Project #21-032
Mountainside Estates Subdivision
Located at approx. 1200 E 1400 N

Project Name: Mountainside Estates Subdivision
Proponent/Owner: Brent Lawyer / Sugar Plum Logan LLC
Project Address: 1200 E 1400 N
Request: Subdivision Permit
Current Zoning: Neighborhood Residential-4 (NR-4)
Date of Hearing: June 10, 2021
Type of Action: Quasi-Judicial
Submitted By: Tanya Rice, Planner II

Resubmittal 6-17-21

Figure 1 shows the 26.14-acre property

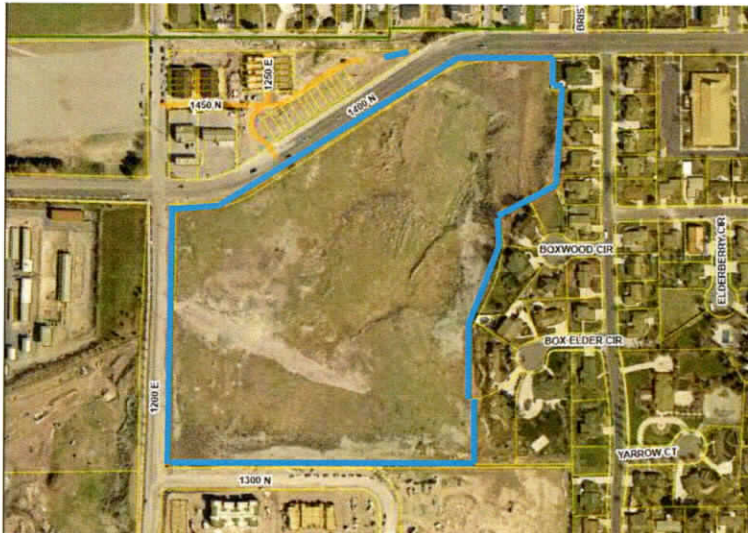
The 26.14 parcel was formerly used as a gravel pit. In 2016, while zoned NR-6, this 26.14-acre parcel was approved by the planning commission for a 76-lot subdivision which has since expired. Since then, the parcel has been rezoned to NR-4. The property was historically used for gravel extraction and processing and remains an abandoned gravel pit today.

DATE: APRIL 2021
DRAWING No. 1

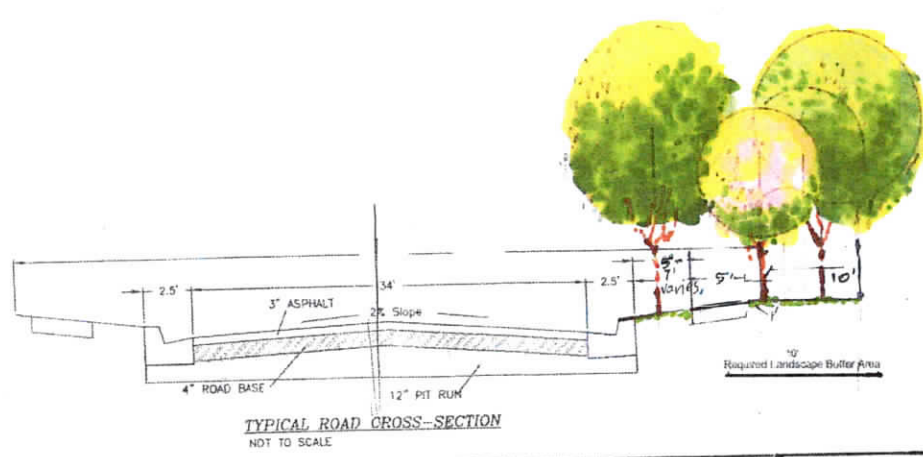
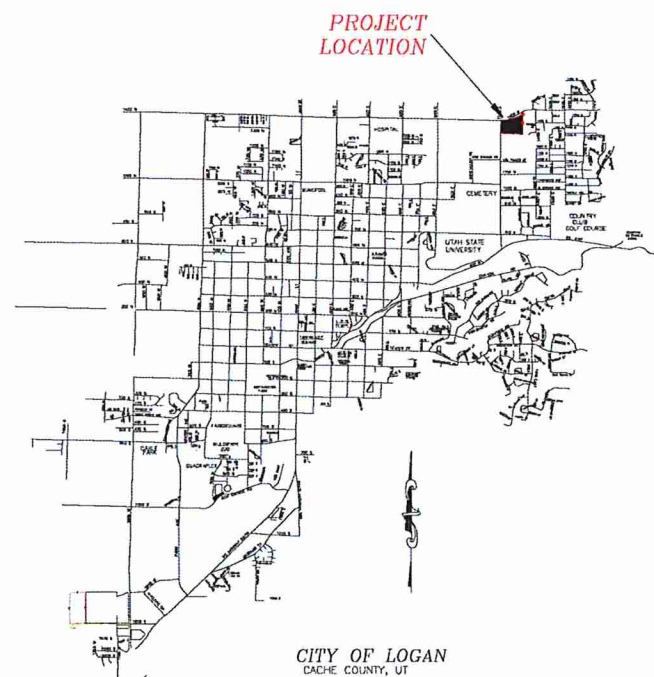
The applicant has resubmitted a plan that shows a realignment of the access road from 1200 E into the subdivision to meet the Public Works Design Standards for collector streets (previous submittal showed access point one parcel-width north of 1300 E). A conceptual landscape design has been provided. The revised plan also adds a 10' landscape buffer along 1400 North and 1200 East (behind Lots 1, 25-31 and 58-64) to ensure uniformity along the streets and privacy for the home owners. The proposed landscape buffer is incorporated into both sides of the detention pond / common area design and is delineated by a uniform 4' fence.

The Logan City Land Development Code (LDC) 17.07.050 NR-4 zoning district allows up to four (4) units per acre and a 10,000 SF minimum lot size and a 90-foot minimum lot width. The proposed subdivision has a gross density of 2.44 units per acre and lot sizes in the subdivision range from 10,100 SF to 29,244 SF. Lot widths are shown at 90' wide or greater. As proposed, the subdivision meets the minimum standards in the LDC.

The LDC requires three (3) street connections for subdivisions greater than 20 lots. Three total street connections are proposed: one (1) onto 1200 East and two (2) onto 1400 North. All internal streets are shown at 60' cross sections with the access points at 66' feet in width. Internal blocks are created by the looping residential streets creating circulation options. The Logan City standard cross section is 60' for residential streets. 1400 North is considered a collector street with an 80' width and 1200 East is considered a residential collector street with a 66' cross section. The collector roads along the perimeter of the subdivision will have an 11'-13' right-of-way width next to the curb and will be improved as parkstrip, street trees and sidewalk. As conditioned with standard street cross sections, the proposed subdivision meets access requirements in the LDC.

The proponent is proposing a 10' wide landscaped buffer between the right-of-way and property lines along 1200 E and 1400 N (adjacent to Lots 1, 25-31 and 58-64). The landscape buffer/open space will be owned by the HOA who is responsible for landscape installation and maintenance. The landscape buffer will comply with minimum planting requirements if 17.09.020.C.6, option for 10' wide buffer. Because the parcels are along collectors, not arterial roads, staff recommends approval for 10' of buffer. The buffer will tie into the retention pond landscaping design located at the northwest corner of the project site to create uniform, aesthetically pleasing landscape perimeter. The open space buffer and detention pond /common area will be owned and maintained by the HOA per 17.29.250. As conditioned, the landscape buffer and required maintenance meet the LDC.

The proposed location of the stormwater detention pond is on the predominant corner of 1400 N and 1200 E and gateway to the Hillcrest neighborhood. As such, design, ownership and maintenance of the detention pond area is important. The proposal integrates the detention pond with common area. A conceptual landscape plan has been provided and incorporates common area, connections with the landscape buffer, detention pond, future playground and additional vegetation. As conditioned, the stormwater detention location is in compliance with the LDC.

3. The stormwater detention pond / common area located at the northwest corner is approved with this subdivision permit.
4. The landscape buffer and detention pond / common area parcel shall be maintained by the HOA. A draft CC&R's shall be submitted to the city detailing landscape buffer responsibility and maintenance prior to final plat approval.

5. The stormwater detention pond / common area located at the northwest corner, and the landscape buffer shall be on a separated parcel from building lots and labeled on the final plat as non-buildable. A note shall also reference the responsibility of the HOA to install and maintain the landscaped area.

6. The landscape buffer shall have trees placed at every 20 linear feet (block average), shrubs at every 10 feet, and 3' berming. Final design to be approved by staff.

7. The storm-water detention pond shall incorporate the edges of the landscape buffer, detention pond, common area, playground and additional vegetation. A final landscape plan shall be approved by staff prior to final plat approval.

12. A note shall be added to the final plat indicating a 20' minimum rear building setback for all homes that back up against 1200 East and 1400 North.

- j) Construct all 1200 East and 1400/1500 North improvements with first phase of construction per Logan City road design standards.
- k) Provide a 10'x10' long corner cut off at south east corner of 1400 North and 1200 East and a minimum 25' radius.

- p) Access to 1200 East shall be spaced from existing roads and accesses per Logan City Design Standards for a Collector type street.
